COMMISSIONING INSPECTION REQUEST (CIR)

MIDFIELD TERMINAL BUILDING, ABU DHABI INTERNATIONAL AIRPORT

COM-CIR-0401-M-02183

TAB CHILLED WATER PUMP - CHWP-CS-L0.0-001 (PUMP-01)

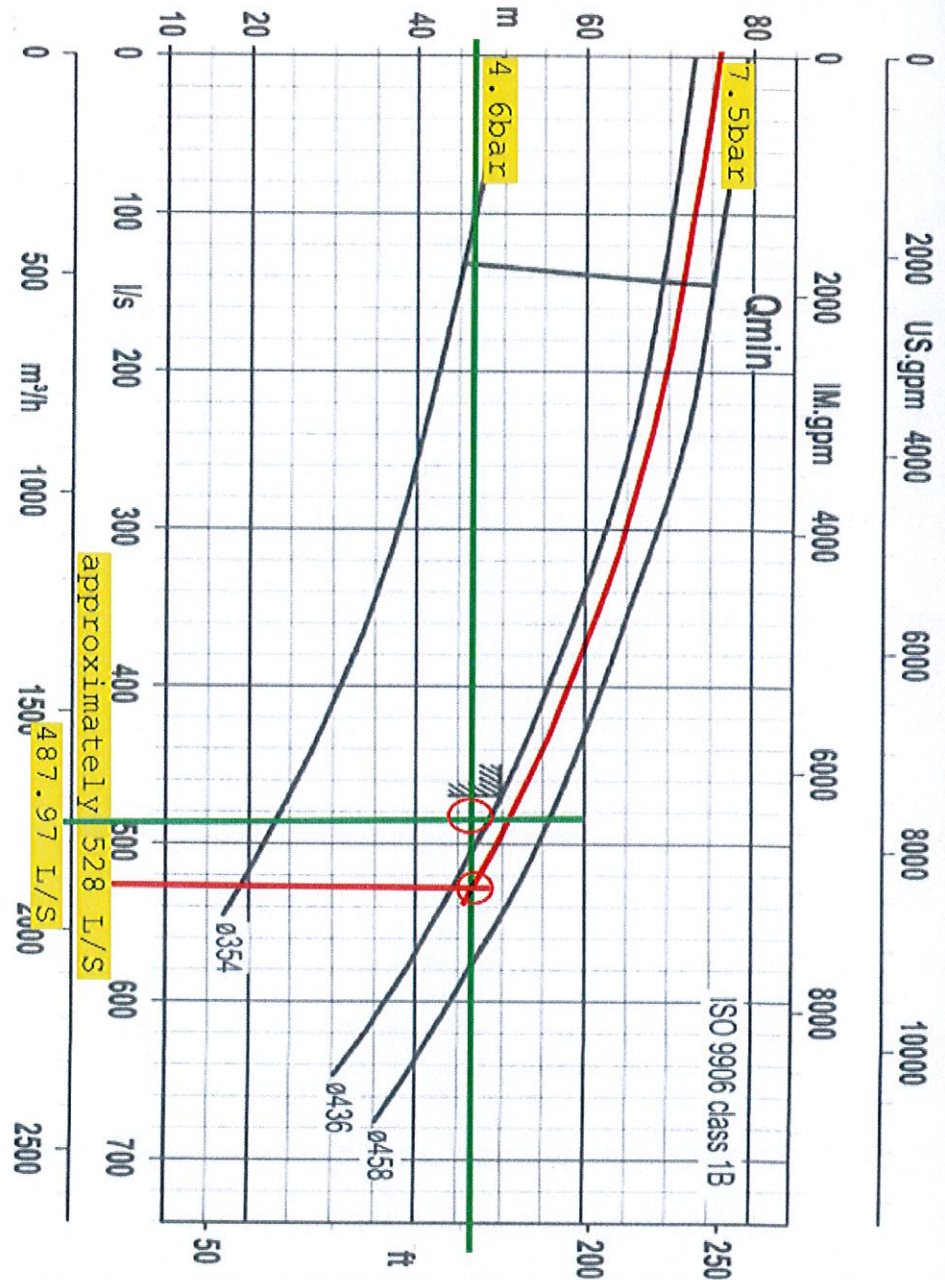
| 13 | Pump curve to confirm plotted results with 50Hz. Curve highlights higher flow than actual flow performance sheets. |

| Project : Midfield Terminal Building, Abu Dhabi International Airport | | ATP No. | Date of CxA Sign | Response Submitted to : CxA | |
|---|---|---|------------------|--------------------------------|--------------------|
| 13 | Pump curve to confirm plotted results with 50Hz. Curve highlights higher flow than actual flow performance sheets. | Performance sheet was obtained through the orifice plate. Shut off head just to check the impeller size and flow rate with high pressure. See attached pump curve | | | |

DRAWING TITLE
**CHILLED WATER PIPE LAYOUT
UPPER LEVEL FOR ETS ROOM
L0.1 PART PLAN SECTOR 5.33C**

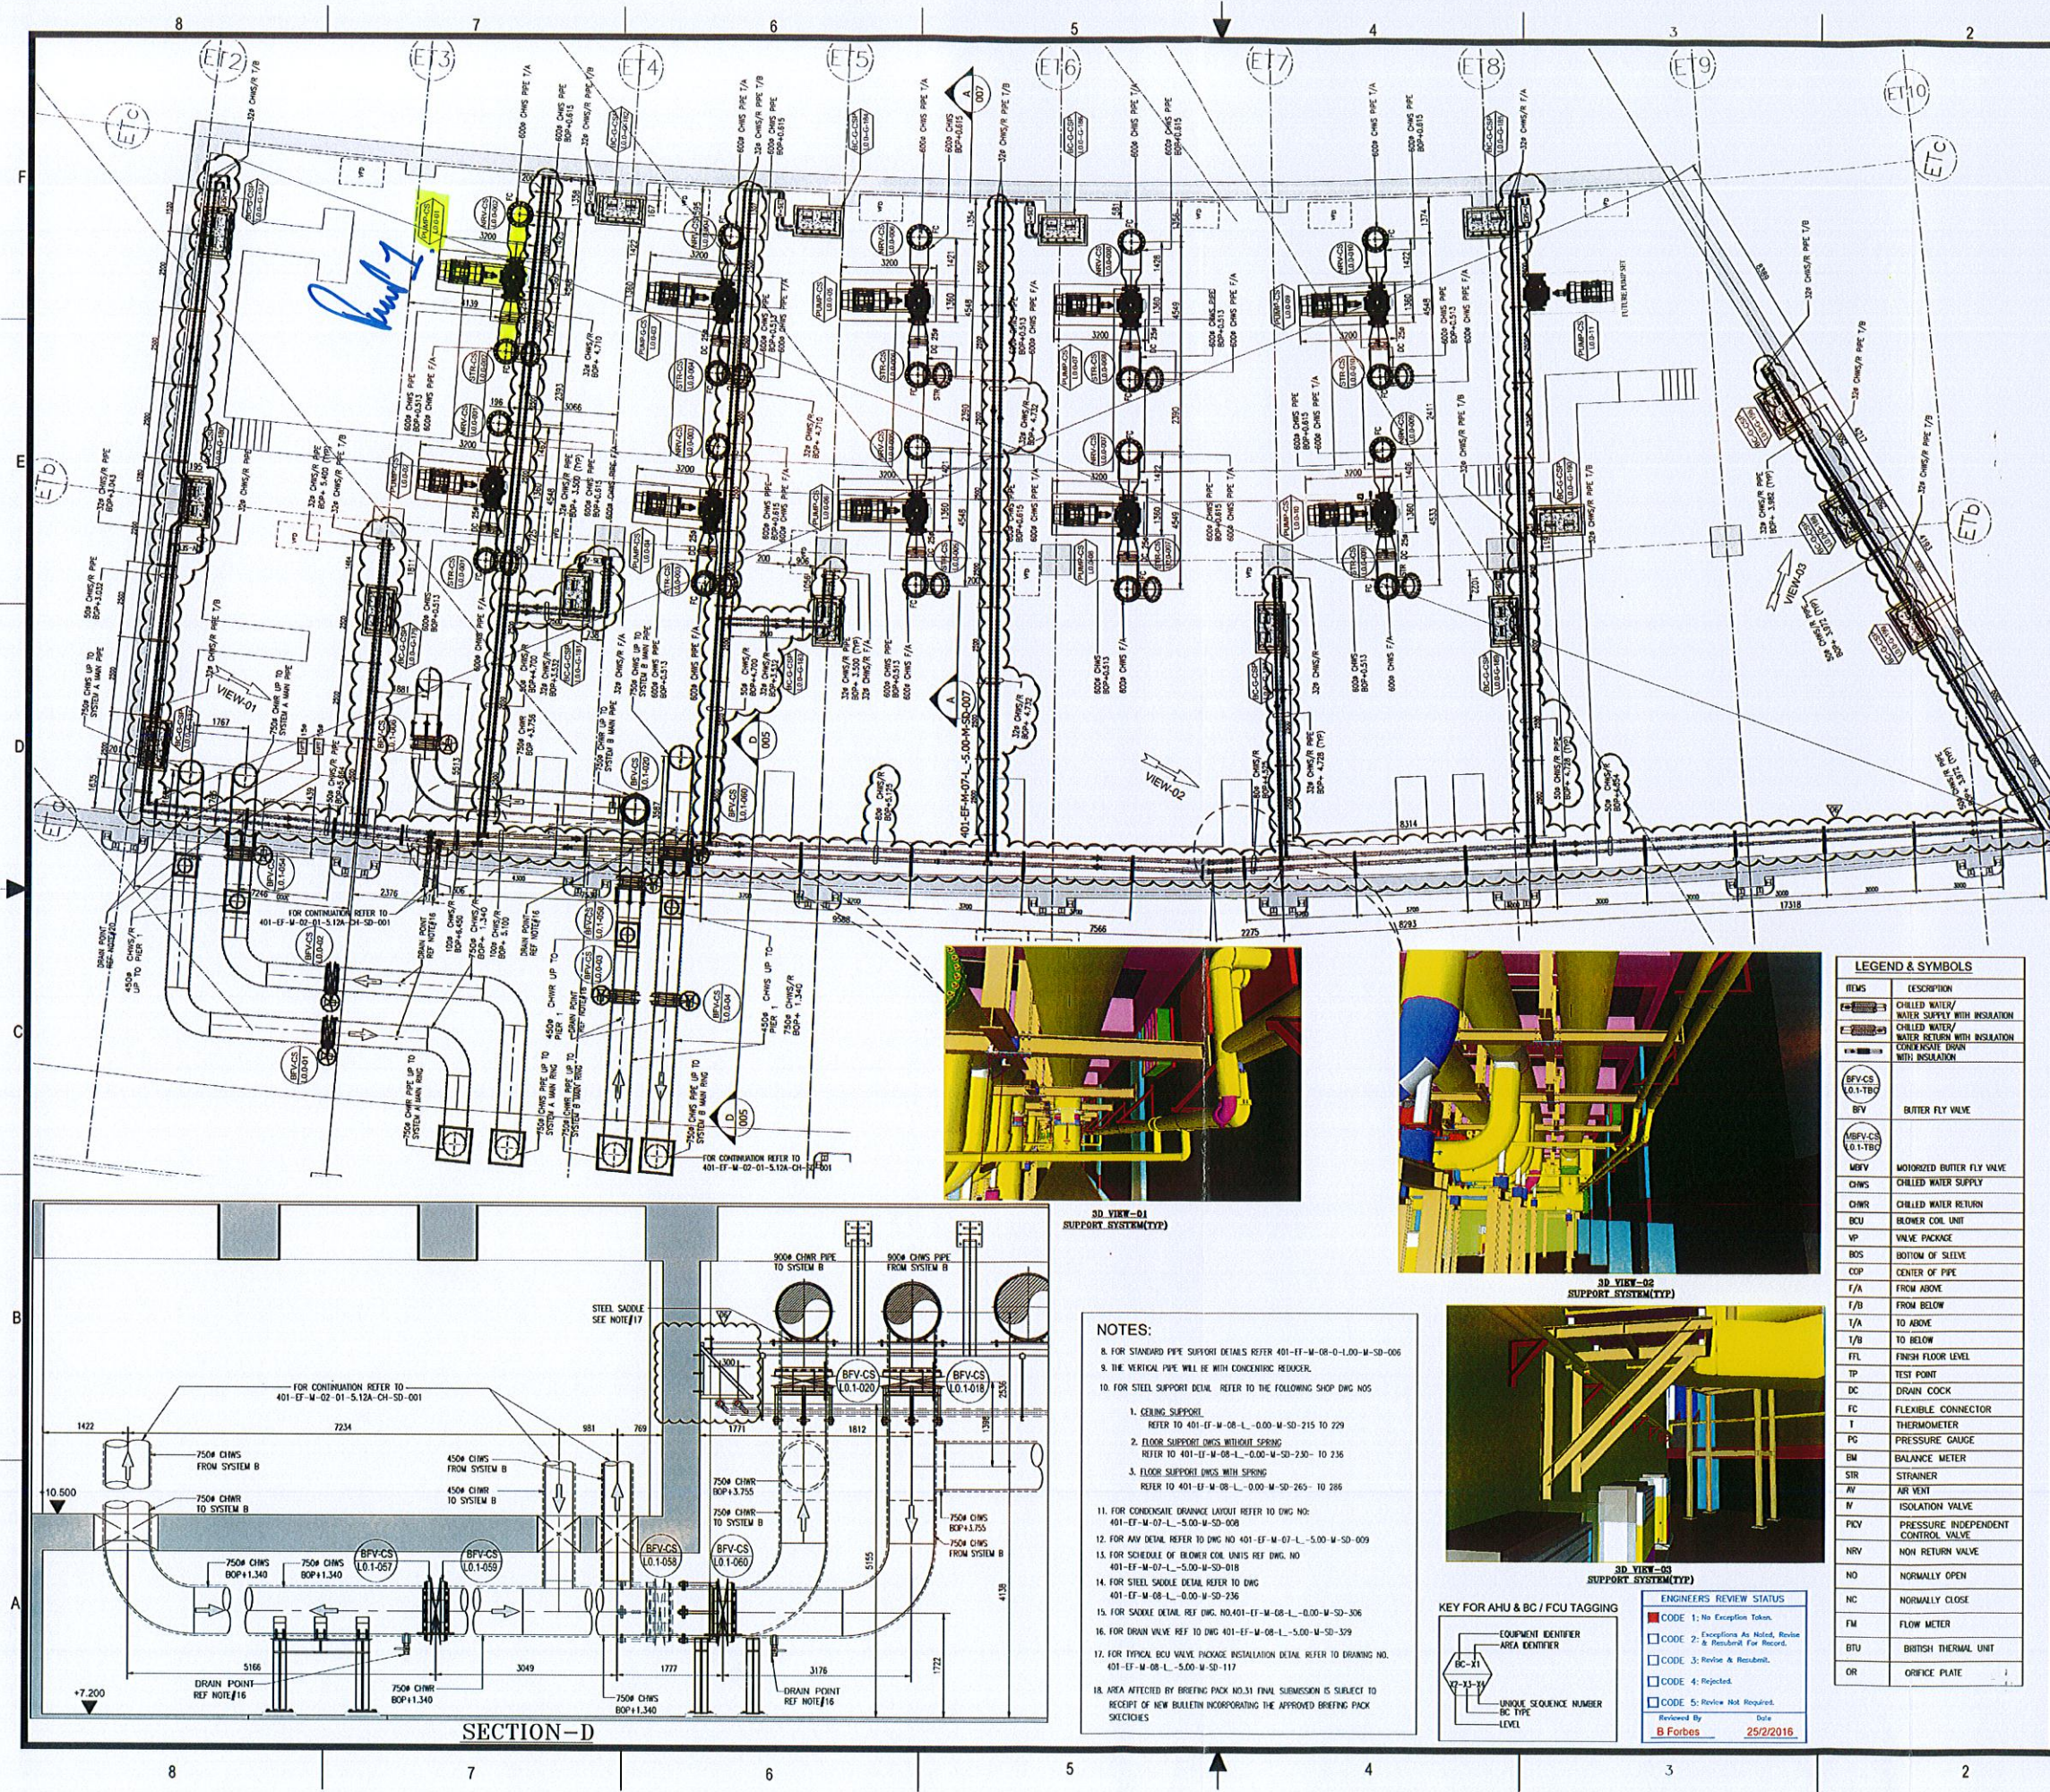
Pipe drop to be coordinate with electrical panel

Show installation detail for AAV
